7. Heritage Alteration Permit with Variances No. 00002 for 721 Government Street (Downtown)

Committee of the Whole Report For the Meeting of December 8, 2016

Subject: **Heritage Alteration Permit with Variances No. 00002 for 721 Government Street**

Re: Heritage Permit with Variance. HAV#00002 – CONDITIONS TO BE MET PRIOR TO COMMITTEE OF THE WHOLE

Proposed Elevations and Sections

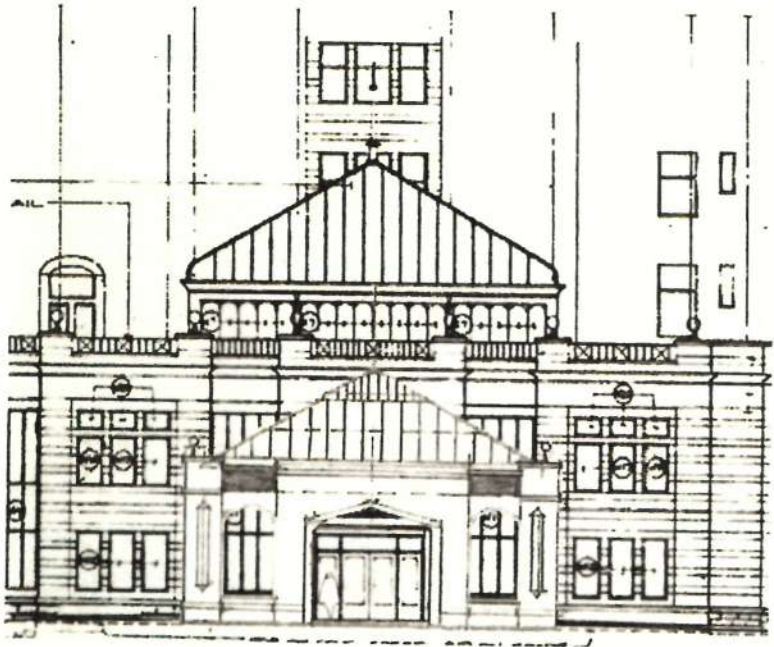
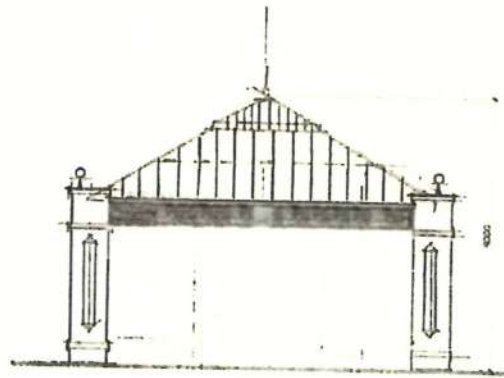
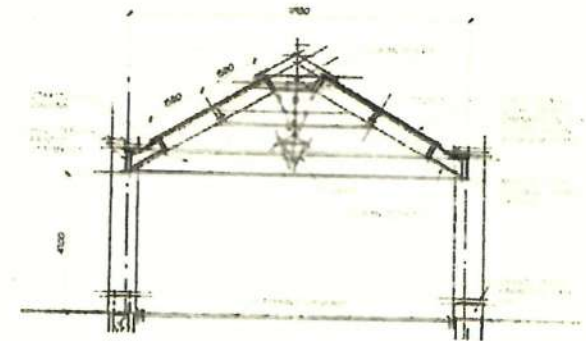
THE PYRAMID ROOF THE CLIENT WISHED TO RETAIN, SEE REASONS ABOVE INCLUDING GROUND CONDITIONS. SOME CALUC REPRESENTATIVES LIKED THE CONCEPT WITH THE ADDITION OF TWO ARCHES THAT HAVE BEEN INCORPORATED TO THE WEST WALL.

Rendered elevations, revised with CALUC committee members additional arch treatment.

ARE PROVIDED

The Existing Canopy Structure will remain. Existing Glass will be removed and the canopy will be extended.

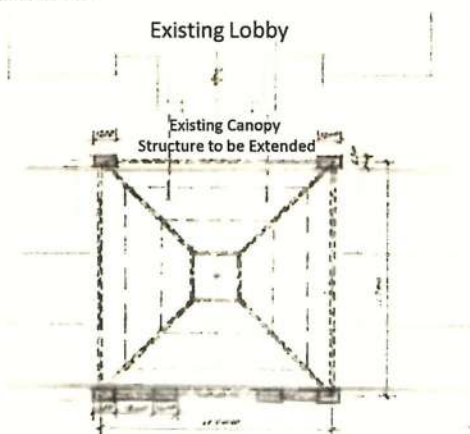
We agree that the piecemeal small sections of the glass sections of the canopy are out of scale with rest of the building, are bitty, and leak. We would remove those small sections of glass and add hss sections to the existing supports so that we can increase the overhang on front and sides, giving a simple glass form in one piece, light but more in scale to the building, while at the same time giving a transition into the addition.

WE AGREE THAT THE EXISTING GLASS SECTIONS ARE NOT COMPATIBLE WITH THE MASSIVENESS OF THE EXISTING BUILDING. THEY WILL BE CHANGED.
